PROJECT: Centennial Heights Townhomes

CITY OF LAS VEGAS		DATE:
INTER-OFFICE MEMORANDUM		June 29, 2020
TO: Land Development Services Department of Building & Safety		FROM: Albert Sung, P.E. Flood Control Project Engineer Department of Public Works
SUBJECT:	Drainage Study for:	COPIES TO:
Centennial Heights Townhomes		Horrocks Engineers
Cross Streets:	SWQ of Centennial Pkwy & Shaumber Road	Harmony Homes, LLC
File Number:	F:\Depot\DSMemos\DS5232D.doc	Bart Anderson, P.E., DevCo
Parcel Number:	126-25-201-010	CCRFCD
Zoning Action:	TMP-77575; VAC-77574; VAR-77573 & ZON-77572	
FEMA Flood Zone	YES	NO X
Proposed Storm Drain	YES X	NO

ADDENDUM #3

**RE: Addendum #3 to Technical Drainage Study for Centennial Heights Townhomes
DS 5232**

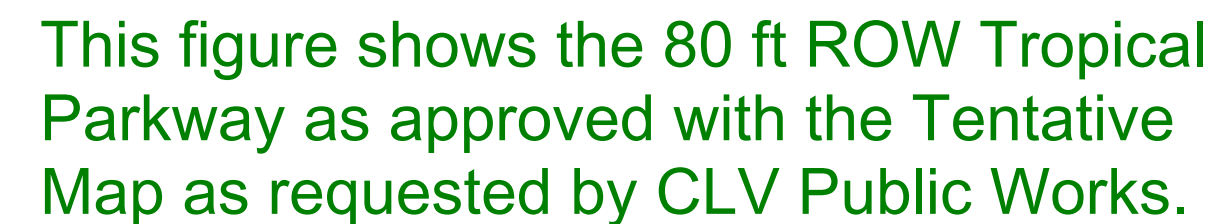
3. **Previous Comment #38** requesting about how in the future when "GOAN 0000" is extended to the west from the west end of the site to the existing Ann Road Detention Basin Outfall Pipe GOAN 0044 but the response was not to the point.

On **Sheet C.5.12**, from SDMH #2, rotate the upstream pipe to align with the downstream pipes. SDMH #1 will be in the street centerline of **Tropical Parkway** as like the other manholes. Provide a 78"-stub at SDMH #1 to the west for future connection. Revise all pertinent plans such as **Sheet C.5.12** and **Sheet C.2.0** accordingly.

The comment to require the storm drain in alignment with downstream pipes will save the reopening of street pavement at SDMH #1 going east when the connection of Ann Road Detention Basin Outfall Pipe is constructed. Review and revise accordingly.

RESPONSE: The storm drain near the Puli alignment and Tropical Parkway has not been relocated per the comment. After a virtual meeting with CLV on June 3, 2020, the comment and the surrounding area was discussed including the issues regarding the proposed facilities by the westerly site (by Olympia and Westwood), the existing ROW alignment and possible future ROW alignment and widths. The proposed location of the SDMH#1 avoids various issues that arise from relocating the alignment. Per the meeting, Horrocks to submit justifications for the storm drain alignment. Justification for the location of SDMH#1 and the alignment of the adjoining storm drain include:

1. Tropical Parkway was realigned at Puli to avoid the NV Energy Transmission Pole at the request of CLV Public Works during the tentative map approval. The storm drain alignment accounts for this realignment.

2. The current location of the manholes/storm drain accommodates the re-aligned 80 ft roadway width and maintains SDMH#1 within the pavement (avoiding curb, gutter and sidewalk.) as requested during a discussion with Westwood.

3. The current location will accommodate a future transition to a 60' street for the Olympia development to the west. The reduction in ROW width is not finalized, but our ongoing coordination with Olympia and Westwood indicates to us that it is a possibility. The ROW width along Centennial Heights Townhomes project frontage is not proposed to be reduced to 60 ft.

4. The proposed storm drain/manhole location is within the current ROW. Revising the facility location to outside the ROW would trigger additional coordination and agreements with the landowner to the south (BLM) including a permissions to grade agreements.

5. The current location will avoid a relatively deep excavation within the existing NV Energy easement and existing 20'x40' NV Energy maintenance pad area which could jeopardize the corner anchor transmission pole stability.

6. The current design accommodates the submitted Westwood storm drain design as submitted with their TDS (DS). The pertinent grading plan sheets from the Westwood Study can be found in the Appendix.

Tropical Parkway ROW alignments Exhibits

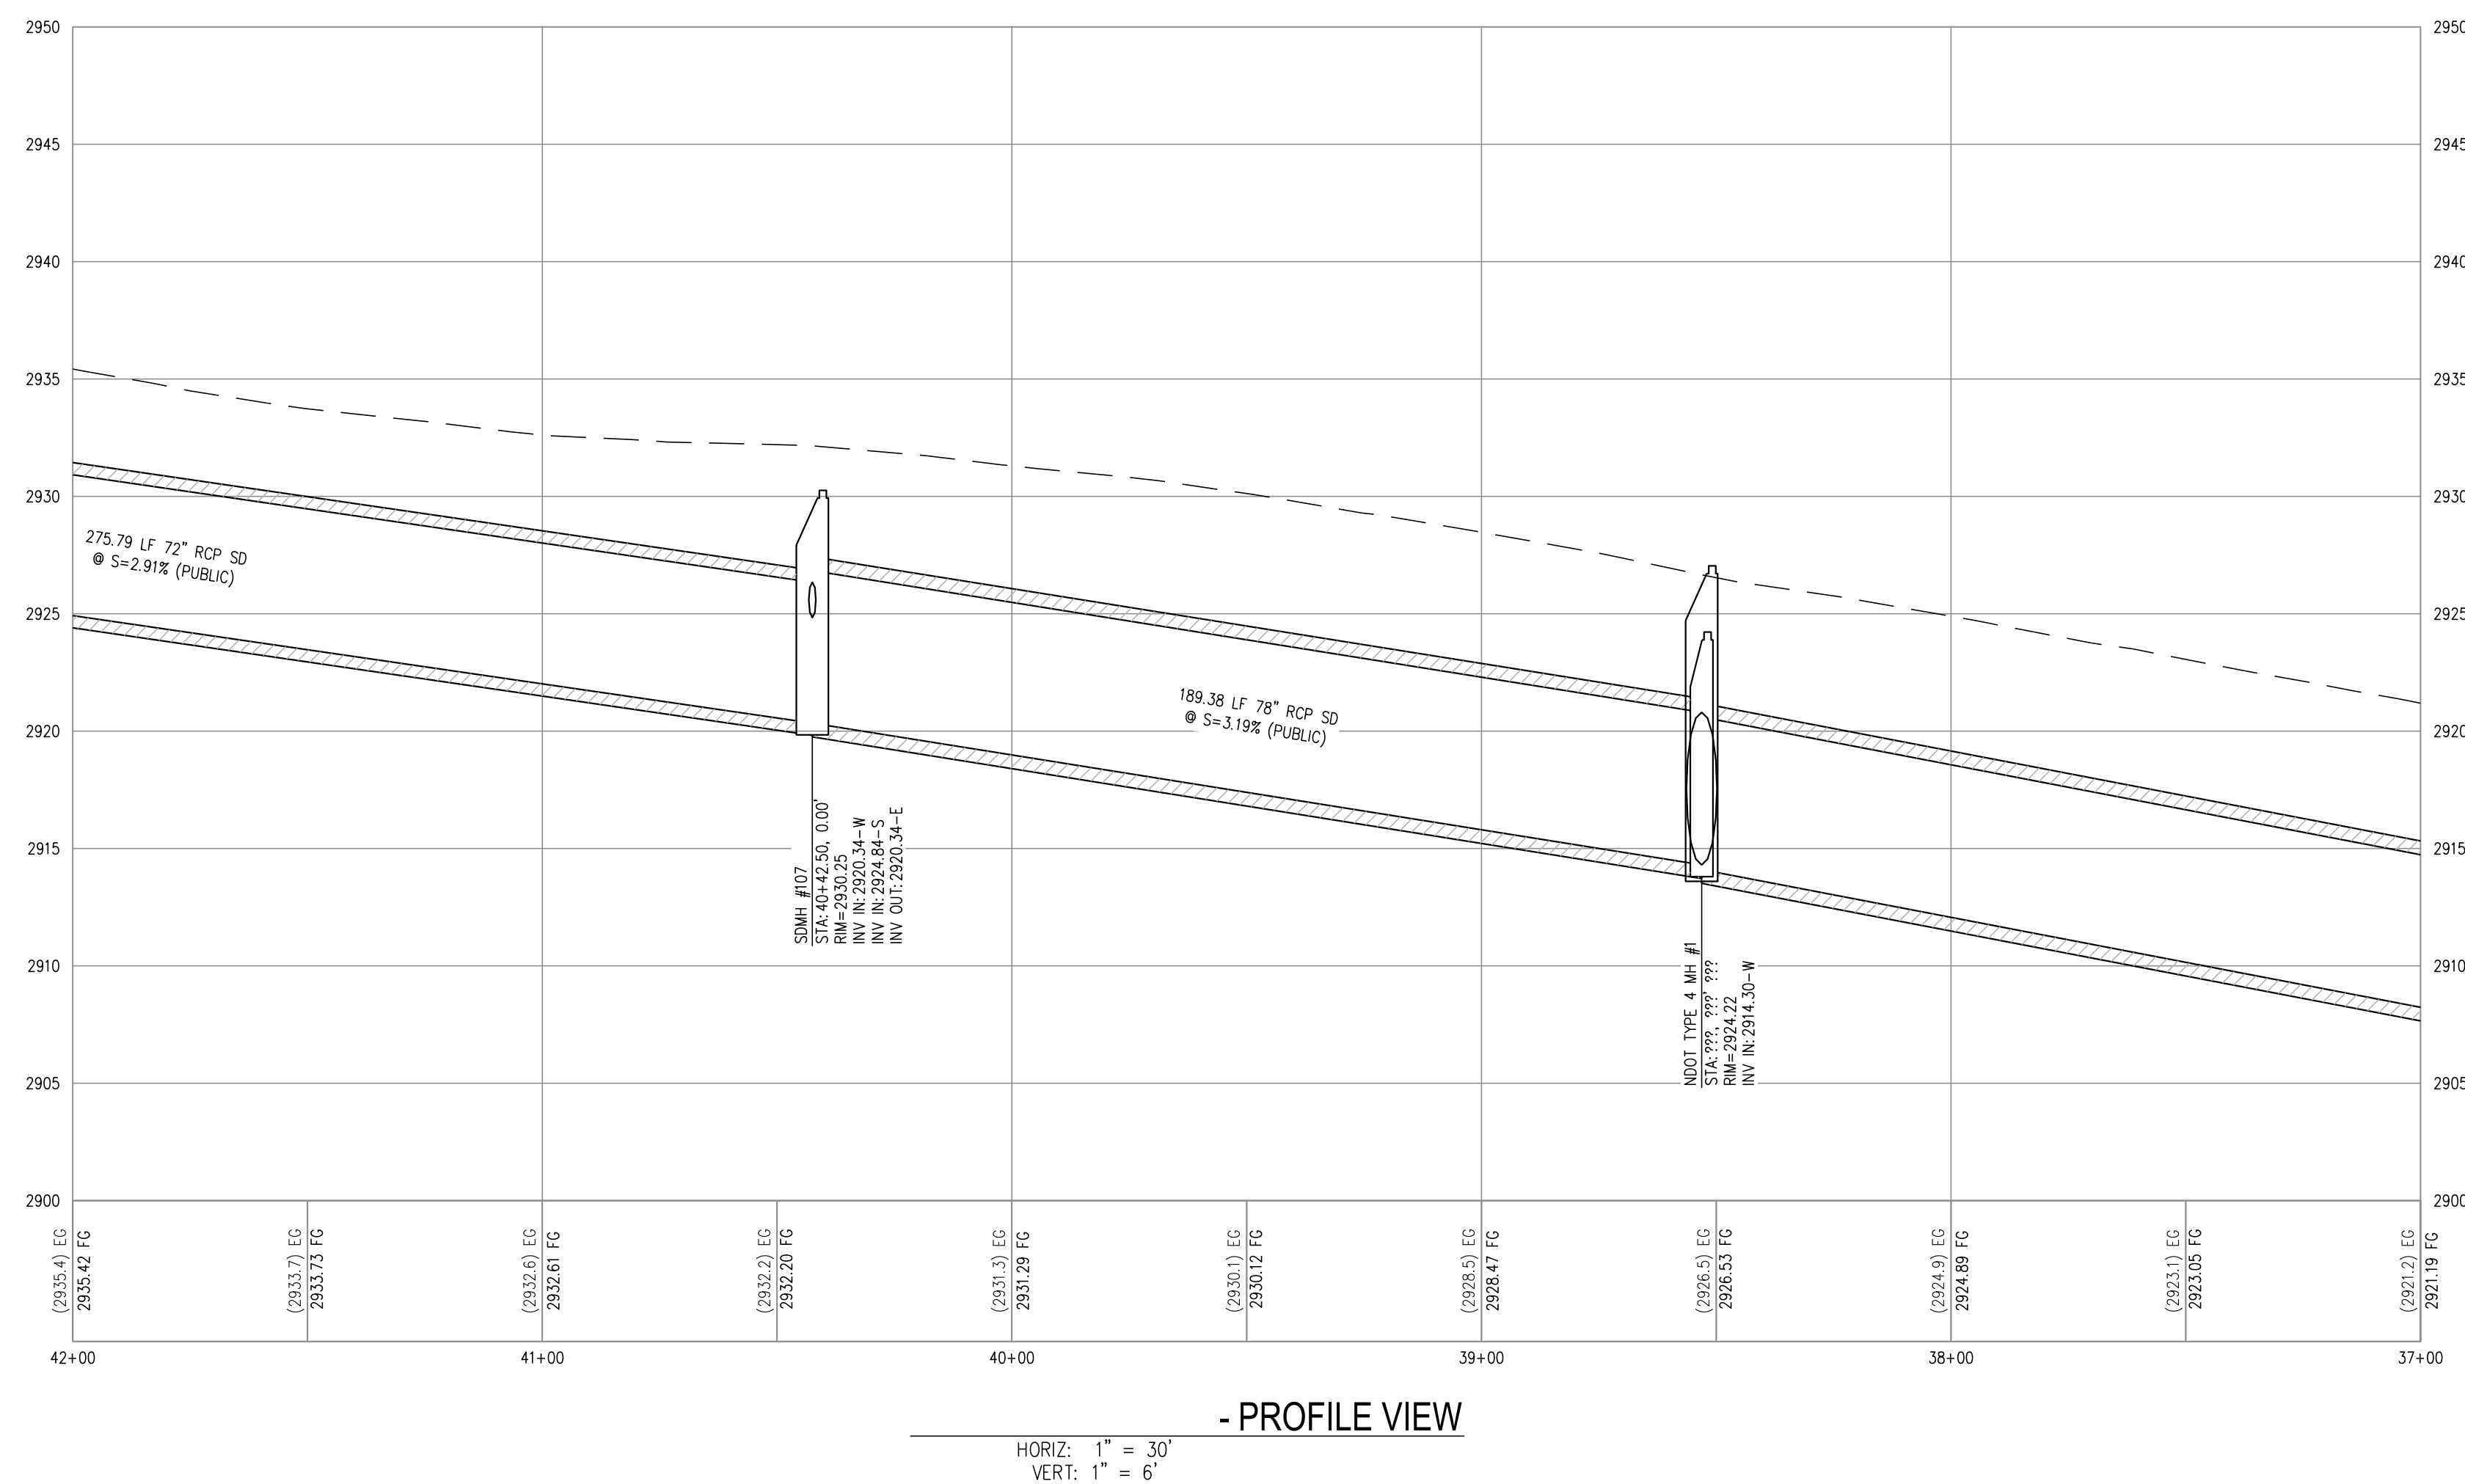
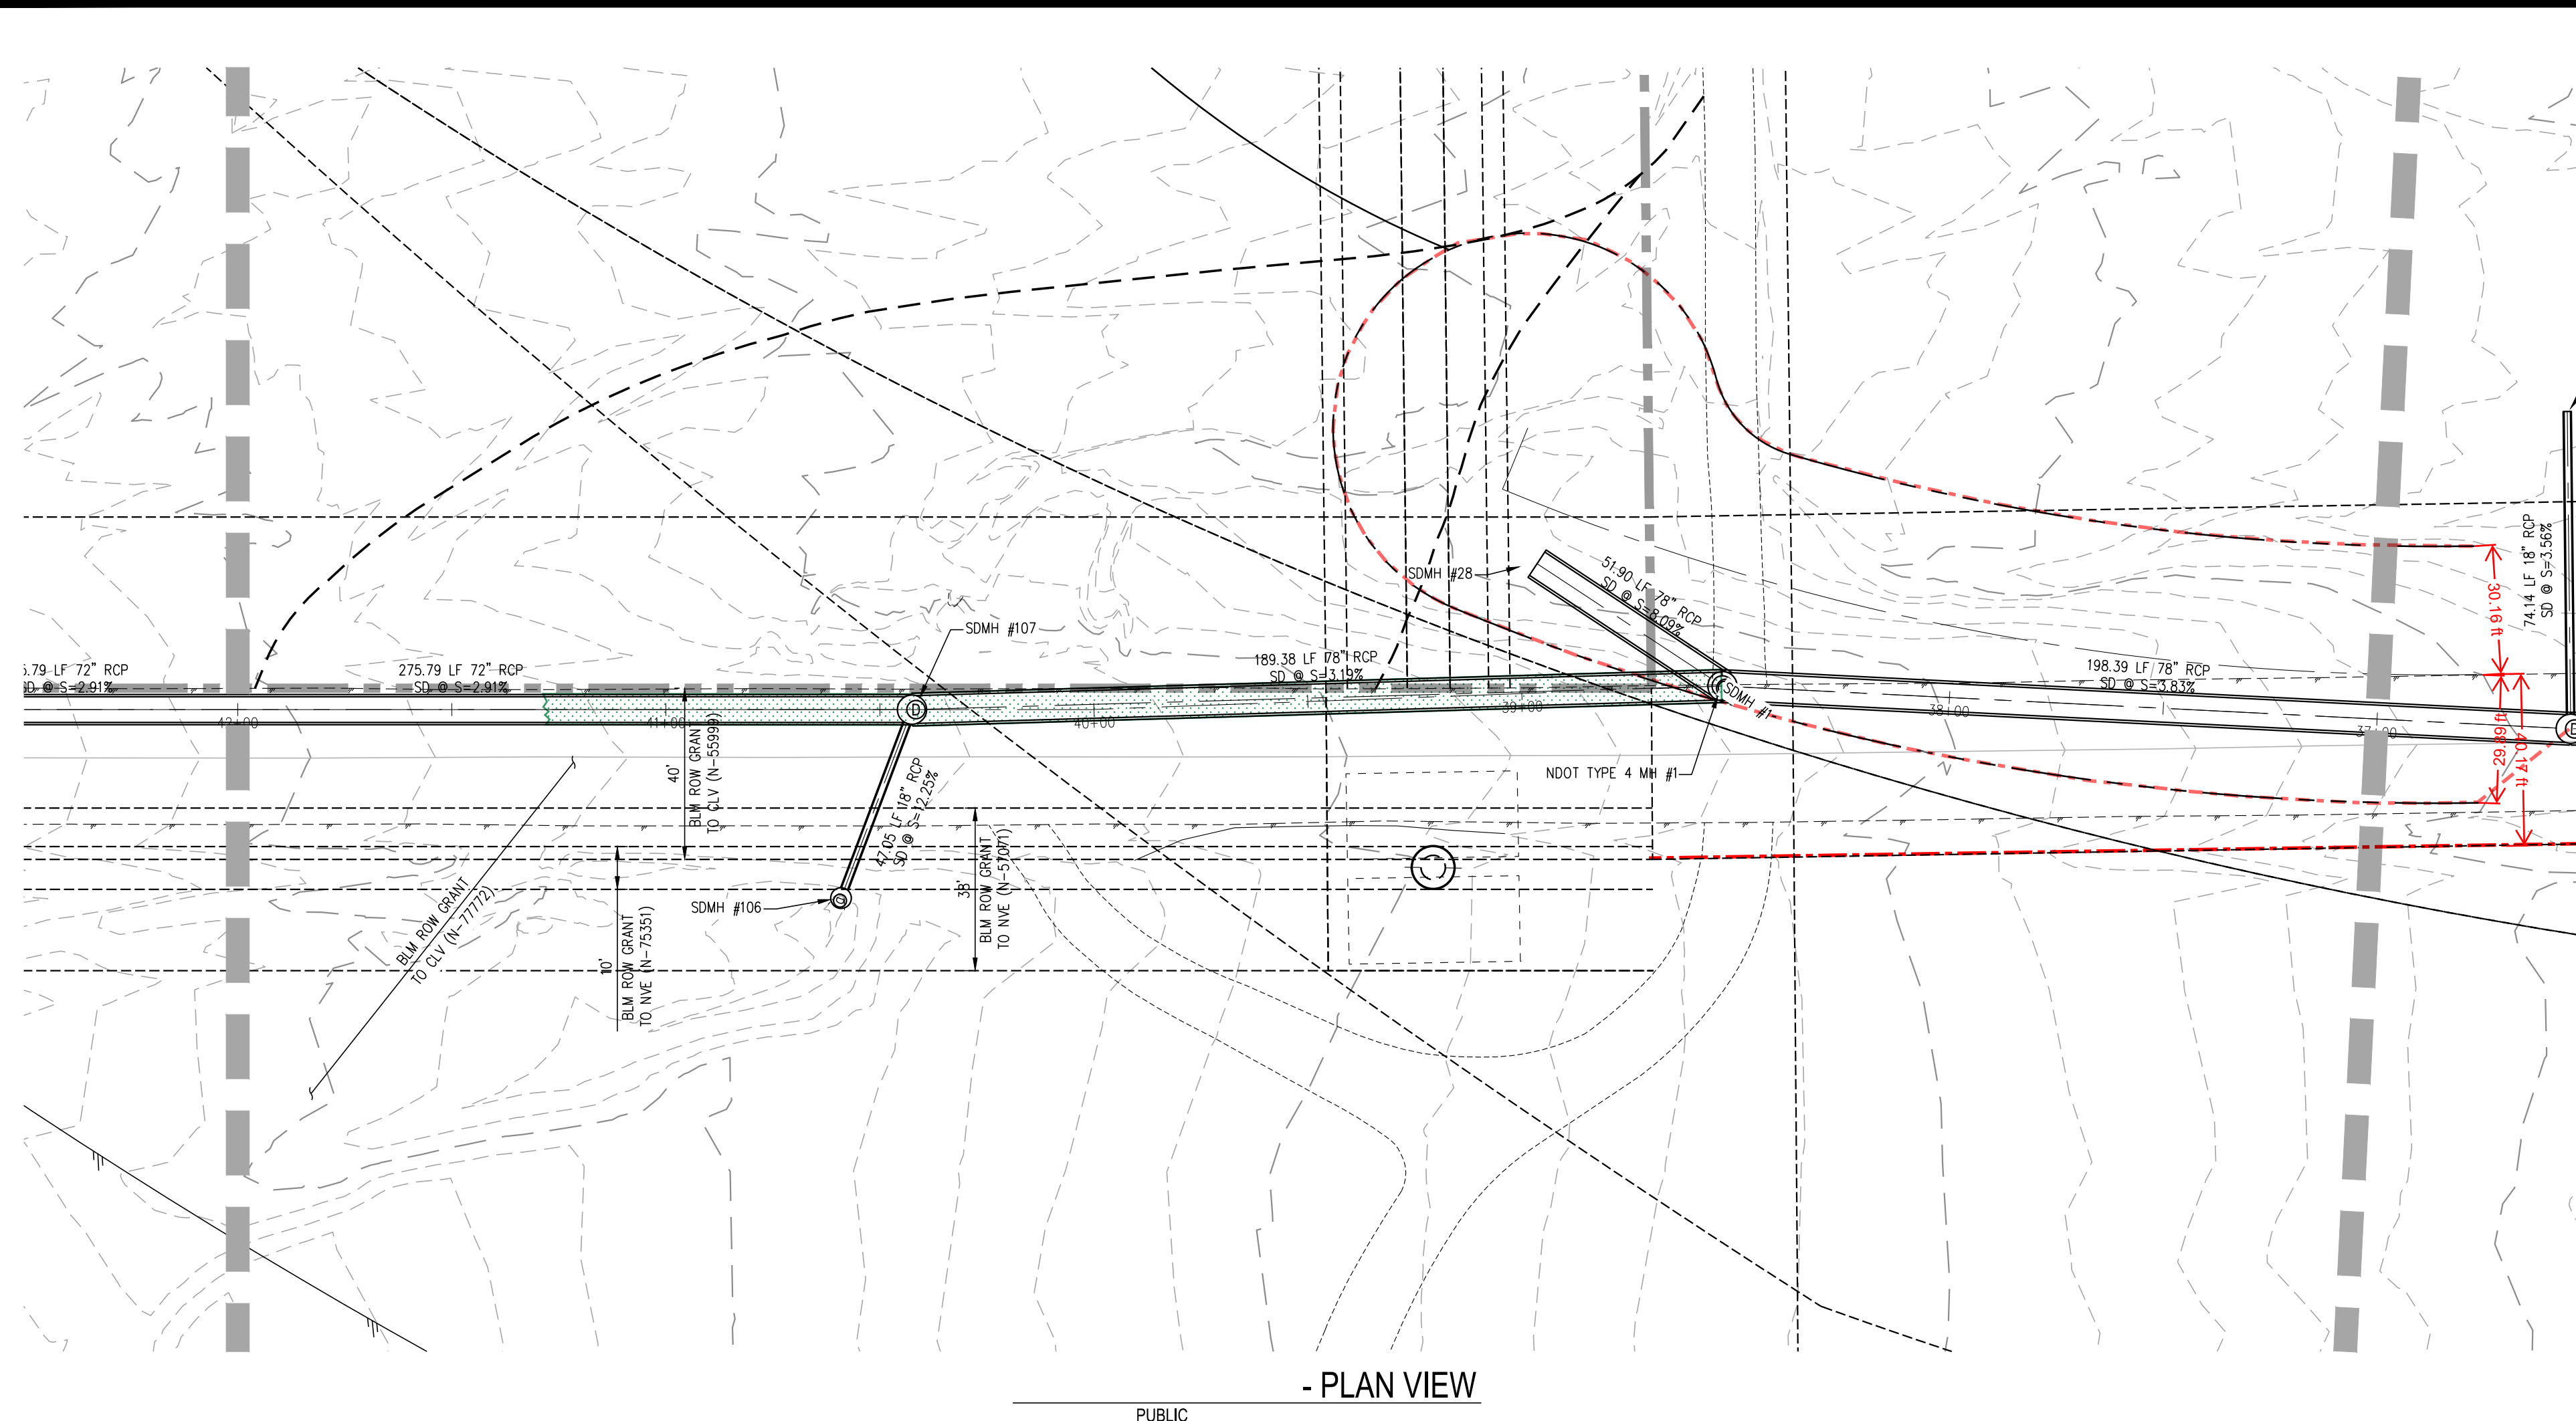
3. Previous Comment #38 *requesting about how in the future when "GOAN 0000" is extended to the west from the west end of the site to the existing Ann Road Detention Basin Outfall Pipe GOAN 0044 but the response was not to the point.*

On Sheet C.5.12, from SDMH #2, rotate the upstream pipe to align with the downstream pipes. SDMH #1 will be in the street centerline of Tropical Parkway as like the other manholes. Provide a 78"-stub at SDMH #1 to the west for future connection. Revise all pertinent plans such as Sheet C.5.12 and Sheet C.2.0 accordingly.
